BALTIMORE COUNTY PUBLIC SCHOOLS

ADDENDUM NUMBER _1_

BID NAME: NEW SCHOOL CONSTRUCTION LANSDOWNE ELEMENTARY
SCHOOL/DEMOLITION OF LANSDOWNE ELEMENTARY
SCHOOL__

BID NUMBER: **MBU-516-17**

SK- C -12

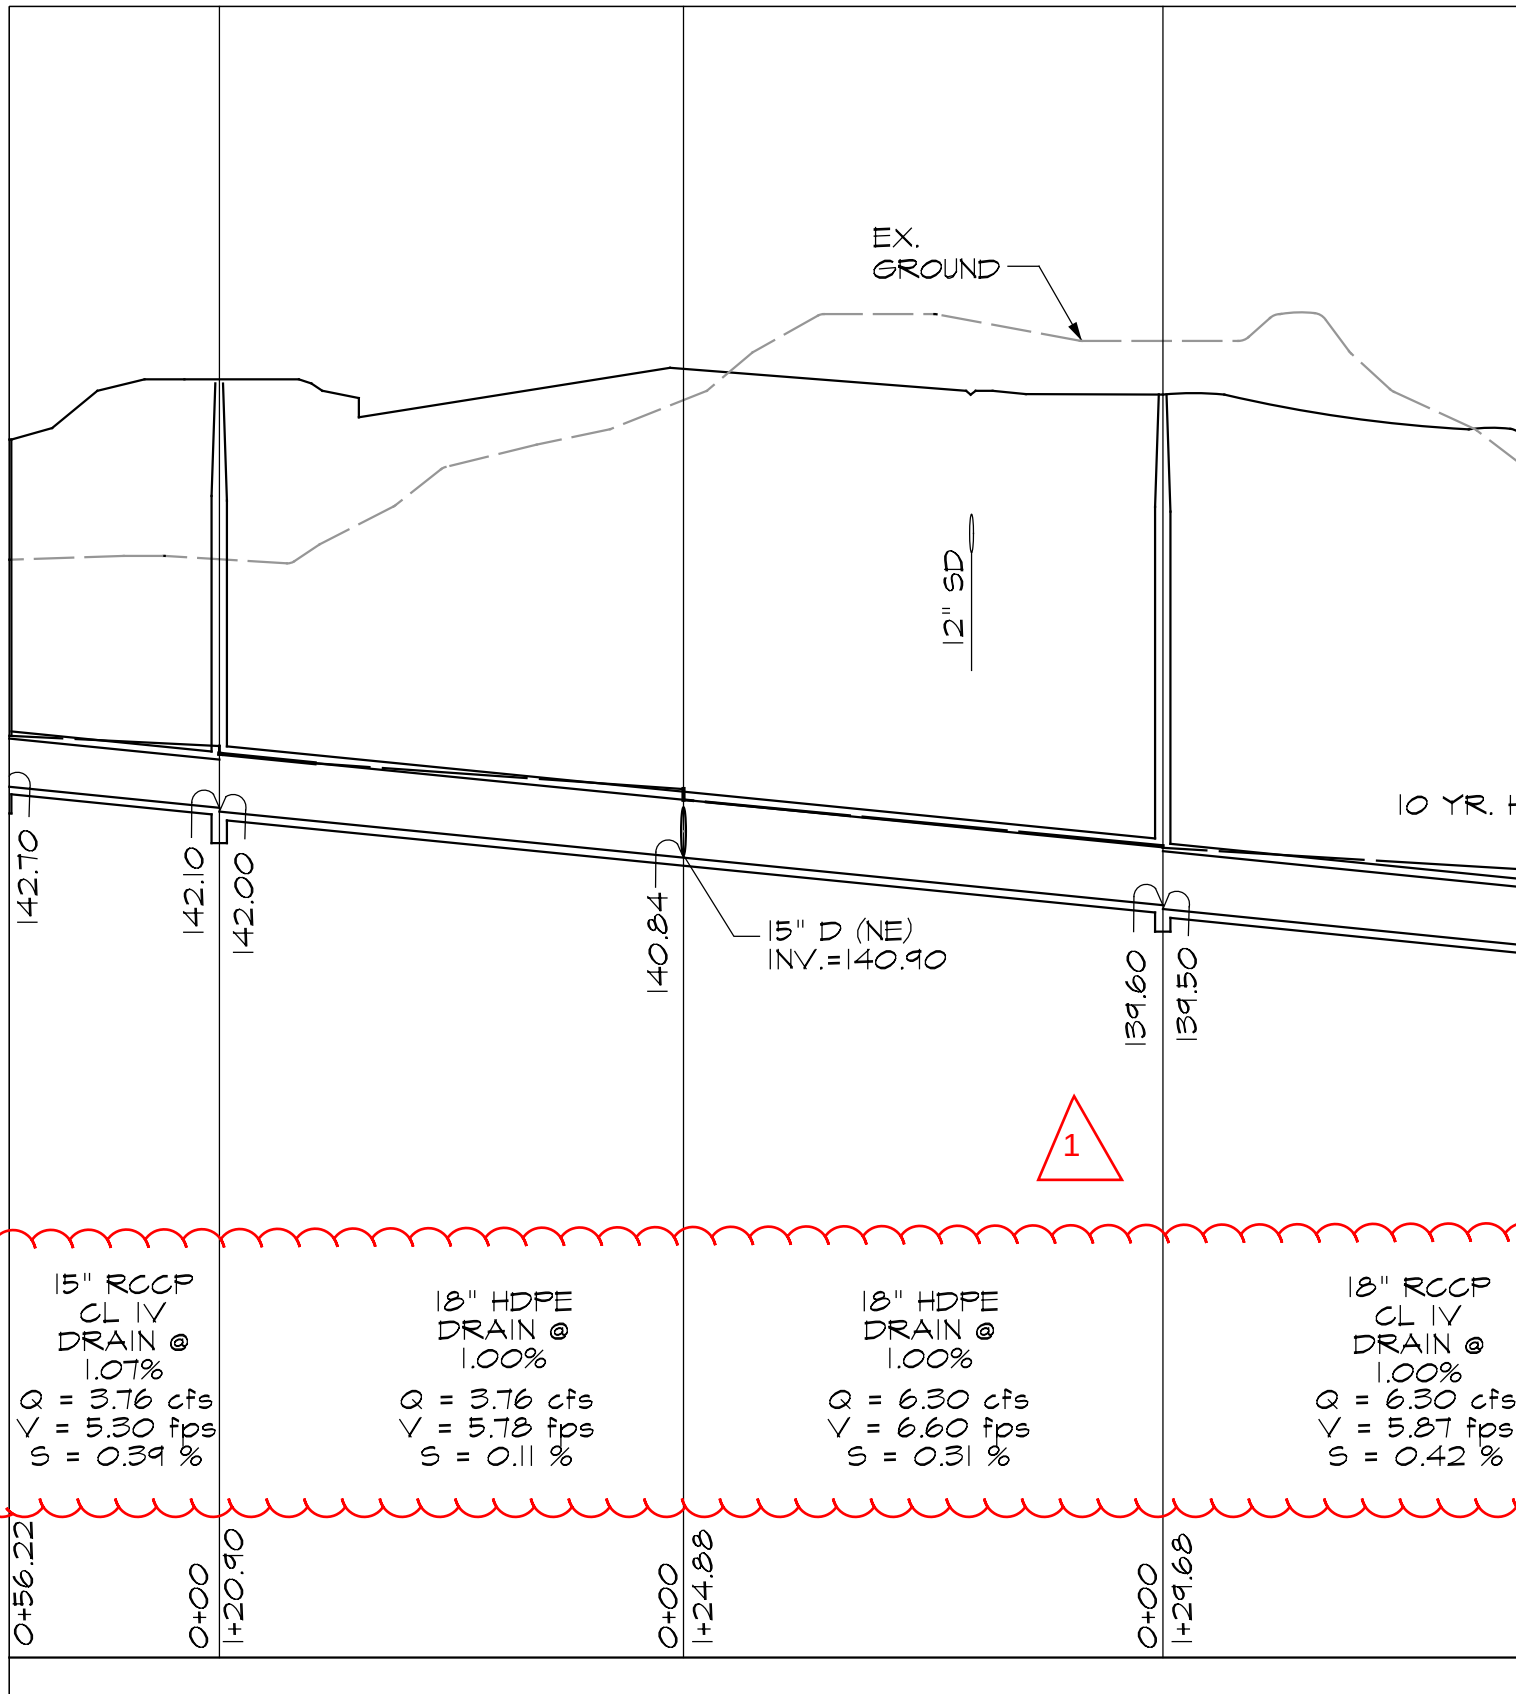
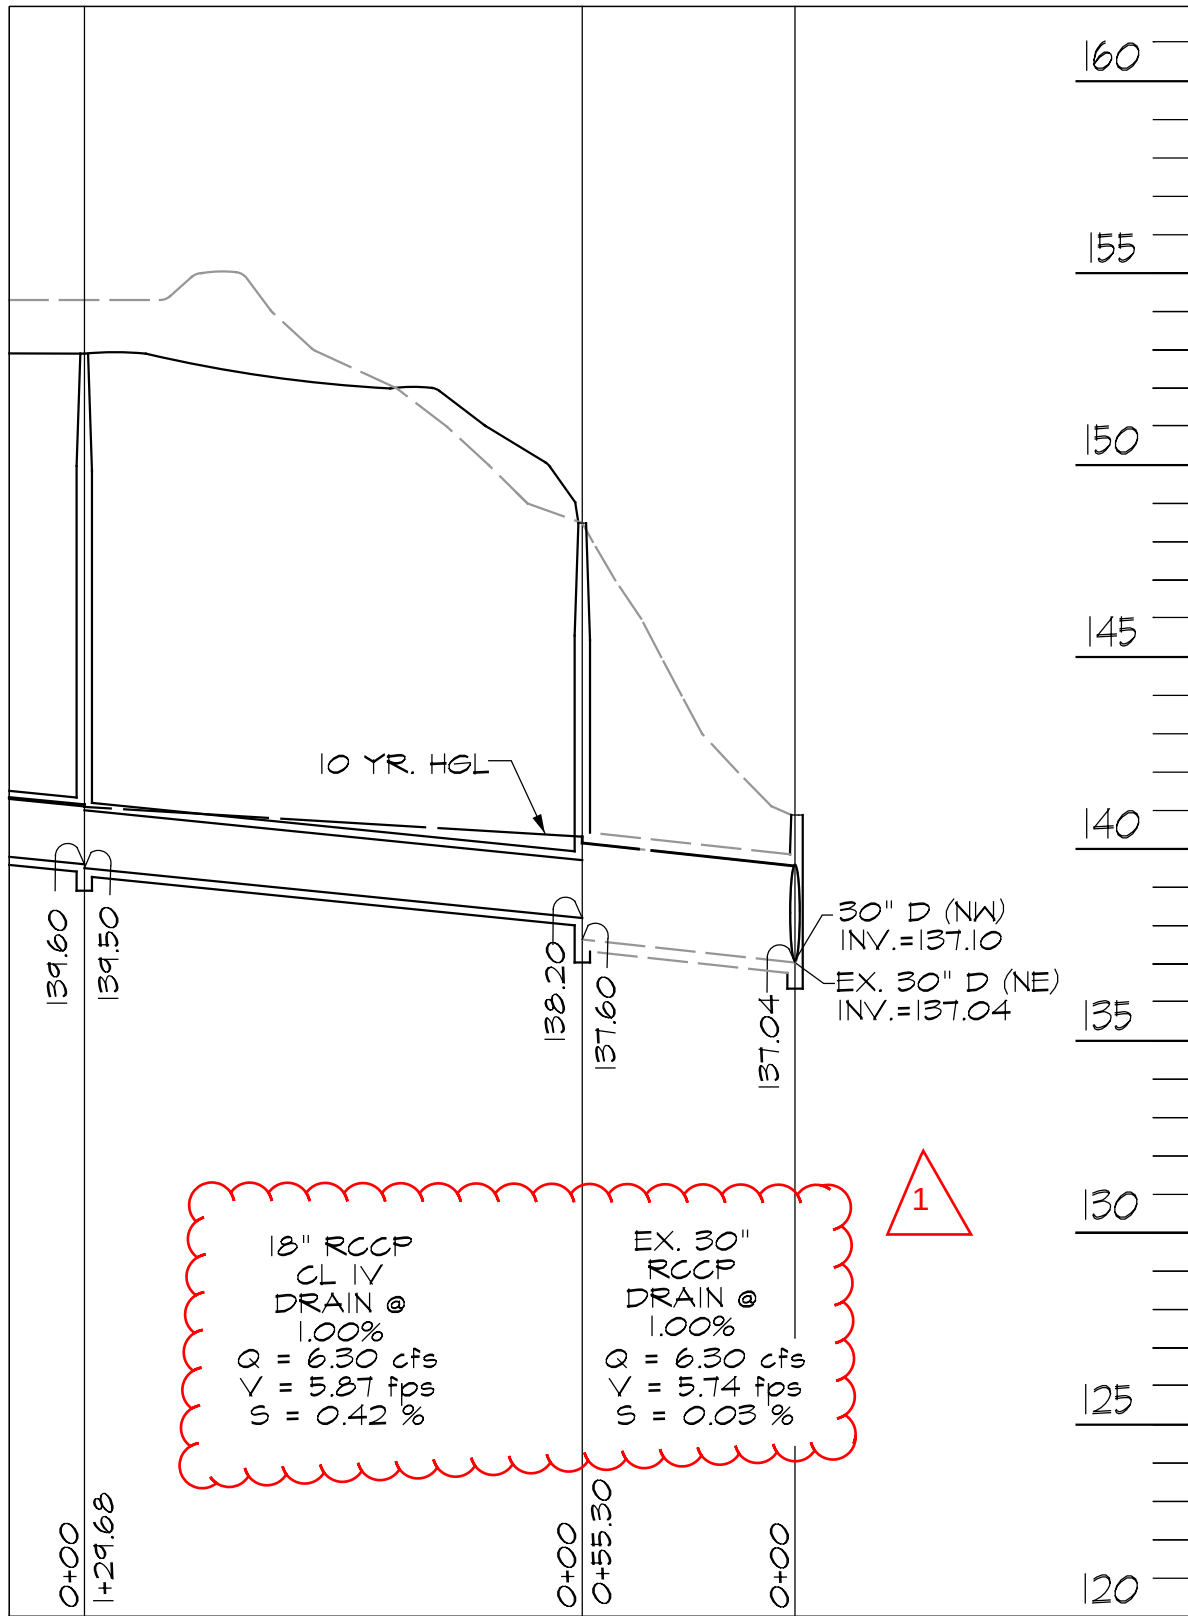
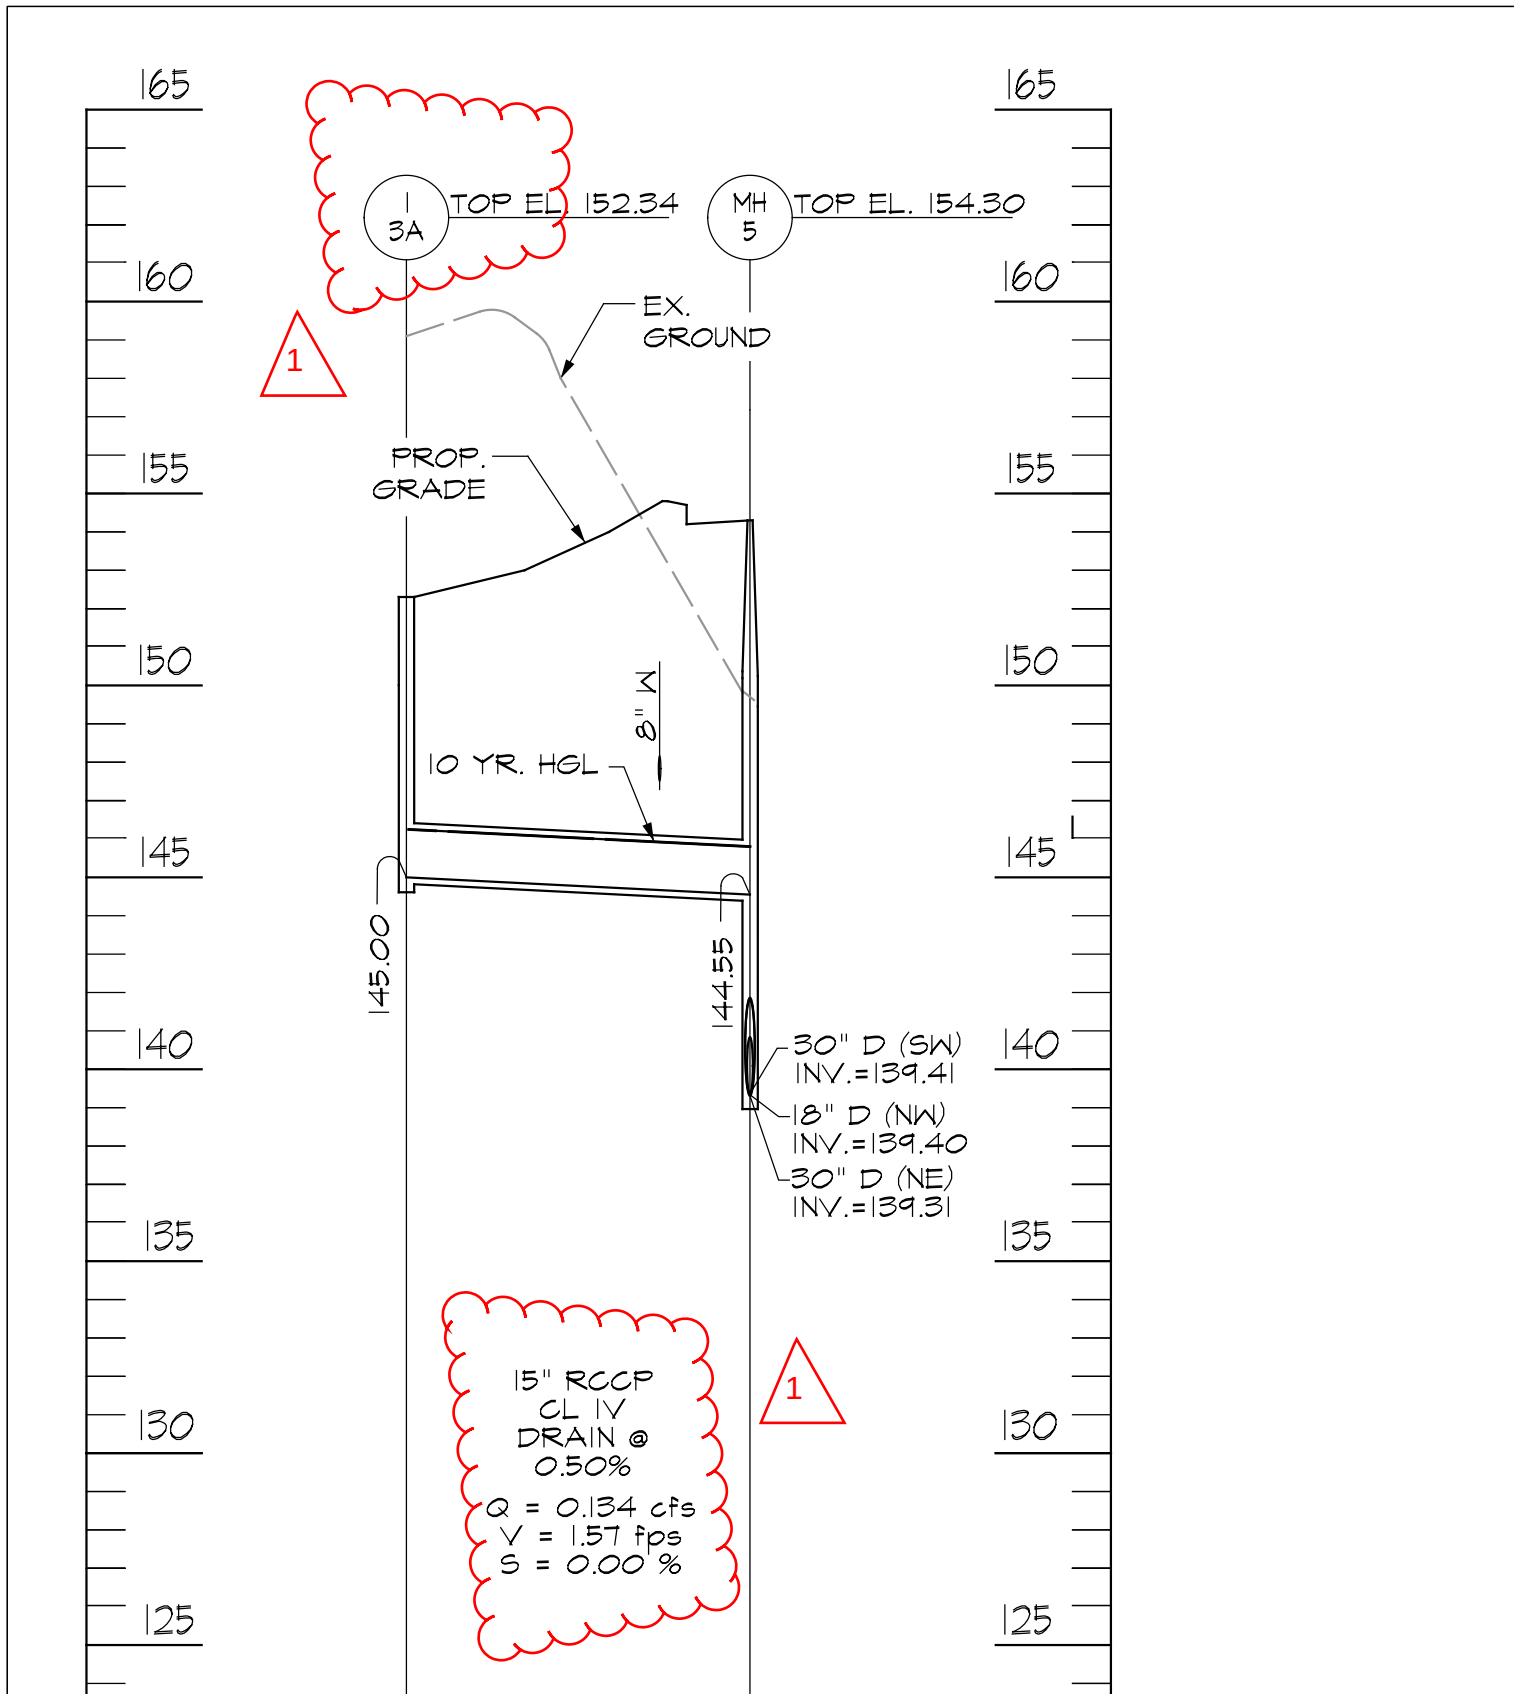
- 3.12. SHEET C-4.4, UTILITY PROFILES
REVISE: Storm Drain Profiles as indicated in attached sketches SK-C-11 – 11G.
- 3.13. SHEET C-4.5, UTILITY PROFILES
REVISE: Storm Drain Profiles as indicated in attached sketch SK-C-12 – 12E.
